# UNITED STATES DEPARTMENT OF THE INTERIOR BUREAU OF LAND MANAGEMENT

SUNDRY NOTICES AND REPORTS ON WELLS  Do not use this form for proposals to drill or to re-ente Paip Artesia abandoned well. Use form 3160-3 (APD) for such proposals.					Lease Serial No. NMNM82896     If Indian, Allottee or Tribe Name											
									SUBMIT IN TRIPLICATE - Other instructions on reverse side.					7. If Unit or CA/Agreement, Name and/or No.

1. Type of Well Gas Well Other: INJECTION					8. Well Name and No. GILA 12 FEDERAL 2 .4		
2. Name of Operator Contact: DAVID STEWART OXY USA INC E-Mail: david_stewart@oxy.com					9. API Well No. 30-015-36401											
3a. Address P.O. BOX 50250 MIDLAND, TX 79710	. (include area code 5-5717 -5742	10. Field and Pool, or Exploratory POKER LAKE DELAWARE, NW

## Oxy USA Inc Gila – 02H API 3001536401, T24S-R30E, Sec 12

OXY USA Inc. - Proposed Gila 12 Federal #2H API No. 30-015-36401

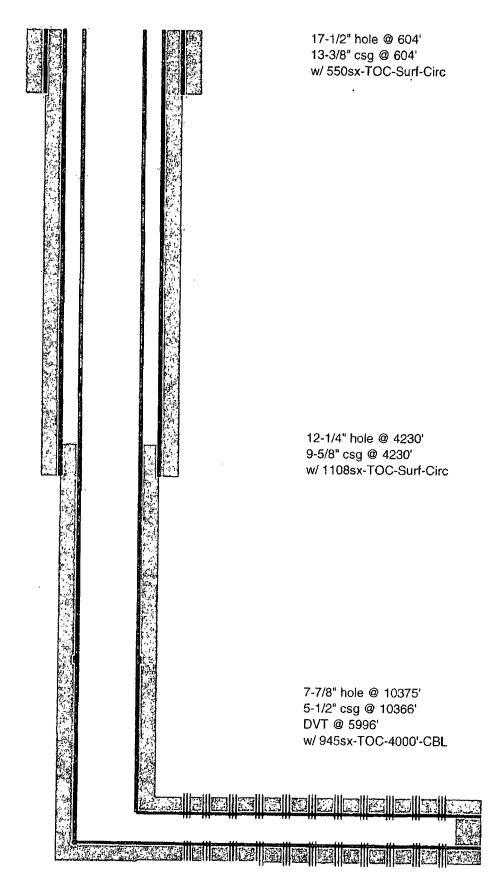
- 1. 1st plug shall be tagged. Plug to be a minimum of 185' in length.
- 2. 2<sup>nd</sup> plug shall be tagged. Plug to be a minimum of 160' in length.

- 11) Records indicate the production casing cement does not overlap the intermediate a minimum of 500 feet as required within designated Secretary's Potash sections. It is necessary that the well's production casing/tubing annulus be maintained full of packer fluid at atmospheric pressure. Equipment that will display on site, continuous open to the air packer fluid level is necessary.
